SYDNEY SOUTH PLANNING PANEL - ASSESSMENT REPORT

Panel Reference	2019SSH008
DA Number	41/2019
LGA	Canterbury Bankstown Council
Proposed Development	Re-development of Canterbury South Public School including minor demolition works to landscape areas/hardstand areas and construction of a three-storey school with a capacity of 690 students and associated landscape works and realignment of car parking along Napier Street.
Street Address	10 – 20 High Street, Canterbury
Applicant/Owner	School Infrastructure NSW C/- DFP Planning, Owner: Department of Education
Date of DA lodgement	26 February 2019
Number of Submissions	Thirty-two (32) Submissions and two (2) petitions
Recommendation	Refusal
Regional Development Criteria (Schedule 7 of the SEPP (State and Regional Development) 2011	Part 4, Clause 20(1) of the SEPP (State and Regional Development) 2011 the application is declared as regionally significant development. Schedule 7 includes 'Crown development over \$5 million'. The proposed capital investment value of \$17,401,00.00 and falls within this category.

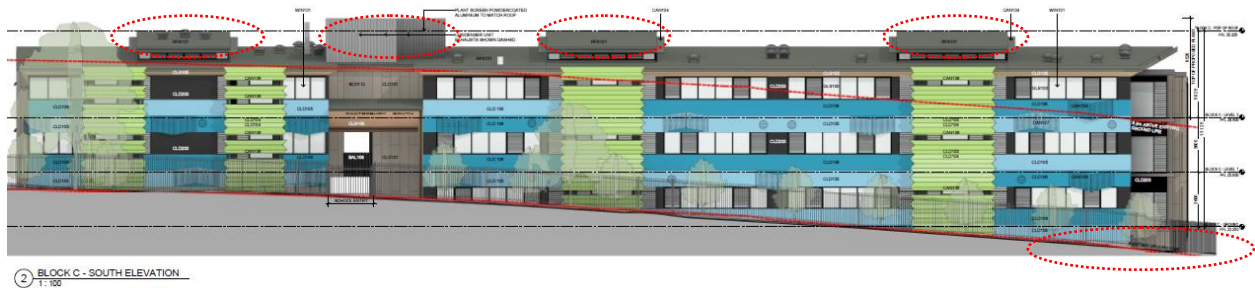
The application is seeking a variation to Clause 4.3 of the LEP which relates to the maximum permitted building height. The application proposes a maximum building height of 13.586 metres, which equates to a 59.8% departure.

The application includes a Clause 4.6 variation. Council is of the view that the height of buildings can be reduced by re-locating the plant equipment from the roof of the structure, removal of the clearstory windows and by stepping the building to reduce the subfloor areas at the eastern end (areas circled on excerpt from south elevation above).

As stated above, the proposed building height can be reduced by re-locating the plant equipment from the roof, deletion of the clerestory windows, and by stepping the building to reduce the subfloor areas at the eastern end of the site. Furthermore, the proposal seeks 3.6m floor to floor, which could be revised to further reduce the overall building height.

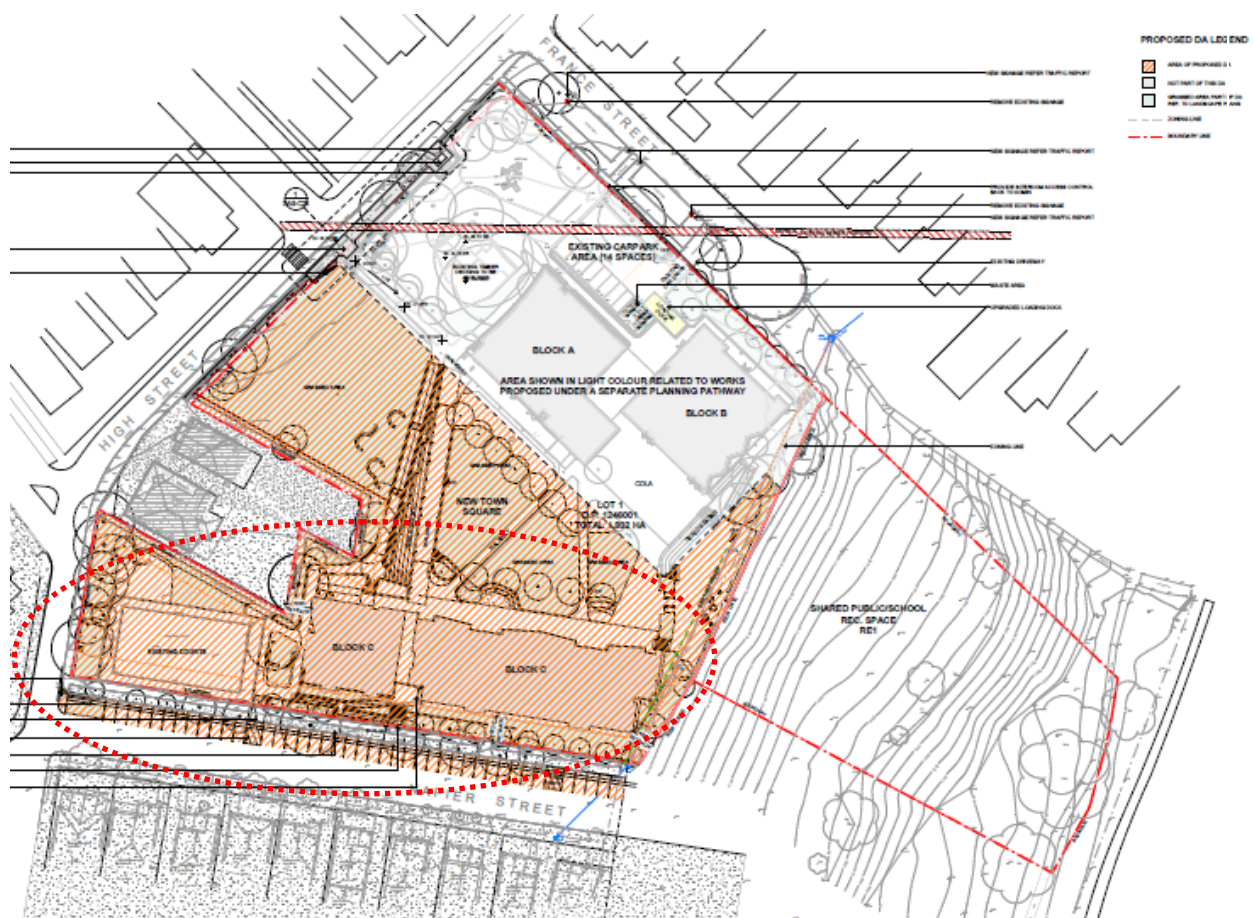
The application is seeking a variation to Clause 4.4 which relates to floor space ratio. According to the LEP Floor Space Ratio Map, the southern portion of the site (R3 zoned land) on which the proposed ‘Block C Building’ is to be located has a maximum floor space ratio of 0.5:1. The remainder of the site is zoned R4 – High Density Residential with a maximum FSR of 0.75:1 and RE1 Public Recreation with no set FSR. The proposal involves a floor space ratio of 0.82:1 on the R3 zoned portion of the site alone.

The application includes a Clause 4.6 variation. The objectives of the Clause 4.4 Floor Space Ratio include “to protect the environmental amenity and desired future character of an area”,
